THE CITY OF KEY WEST PLANNING BOARD

Staff Report

Agenda Item: Minor Development Plan – 218 Duval Street (RE# 00001400-

Request: This application proposes a minor development plan approval for the

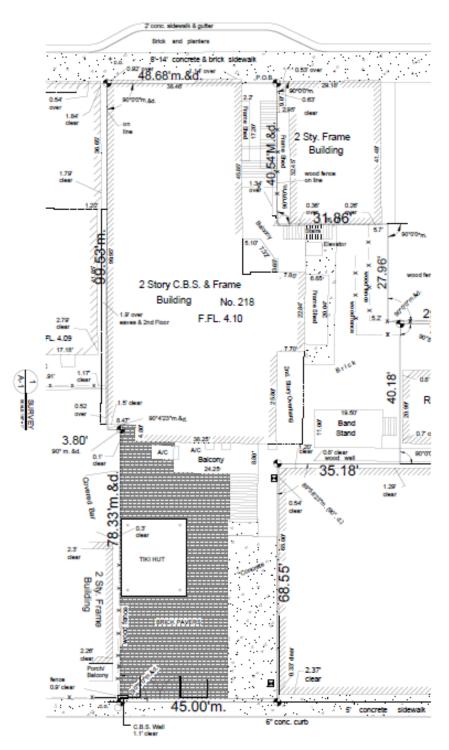
^{*}Site plan sheet references previously permitted Hideaway Bar as part of existing building coverage calculation. Based on the survey submitted, staff is unable to verify whether the existing conditions of the site are consistent with the existing building coverage indicated in the application.
